2021/6257/P 14 Greenaway Gardens

Delegated Report (Members briefing)		Analysis sheet		Expiry Date:	17/02/2022
		N/A		Consultation Expiry Date:	13/03/2022
Officer			Application Number(s)		
Obote Hope			2021/6257/P		
Application Address			Drawing Numbers		
14 Greenaway Gardens London NW3 7DH			Refer to draft decision notice		
PO 3/4	Area Team Signature	C&UD	Authorised Officer Signature		
Proposal(s)					
Partial demolition of existing dwelling with retention of the front and parts of the side and rear façade and the erection of a basement extension, infill rear extension, various minor changes to the fenestration and other associated works.					
Recommendation(s):		Grant planning permission subject to s106 legal agreement			
Application Type:		Full planning permission

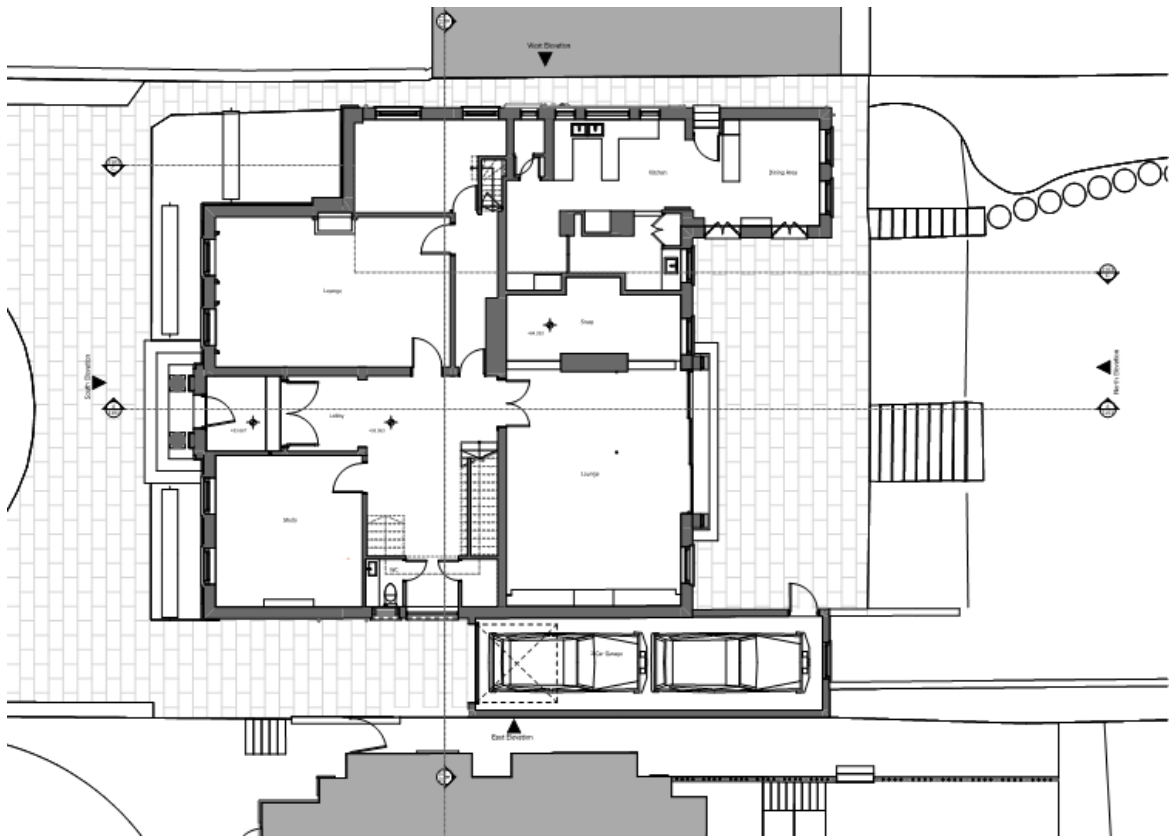
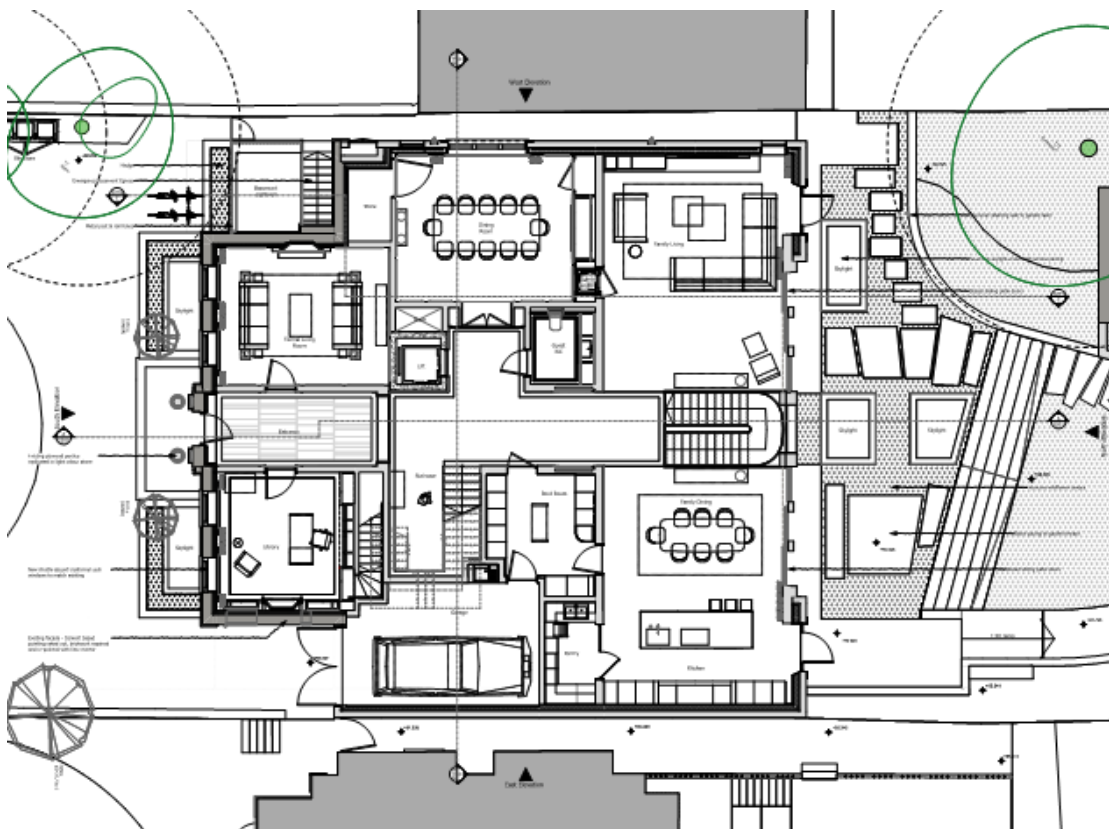
- 1.1 Planning permission is sought for the partial demolition of the existing dwelling with the façades to the front, east and north elevations retained. The proposal includes a single storey rear extension to replace the two existing single storey extensions (one with a flat roof and one with a pitched roof) and a basement extension under the building footprint. A new lift is proposed to enable step free access to all levels of the property, and new roof dormer extensions are proposed to the front, rear and side elevations to replace the existing. The existing front portico and single storey garage would be rebuilt, and the existing chimney breast would be relocated to the north-east elevation, following chimney reconstruction. The proposal would also reduce the amount of covered car parking spaces from two to one, new fenestration treatment to the side elevation and alteration to the front boundary treatment.

- 1.2 The existing pitched roof rear extension is approximately 3.5m at the eaves, increasing to 3.9m high (in the centre), and the flat roofed extension is approximately 3.5m high. The extensions measure 4.2m to 4.3 deep, with a footprint of approximately 32sqm. The proposed full width extension would measure 4.3m in depth and would be single storey measuring 4.2m in height with a green roof. The proposal would include a basement built under the footprint of the dwelling covering approximately 237sqm (including a southeast and southwest lightwells approximately of 3.7sqm in floor area) and an external depth of 3.2m.
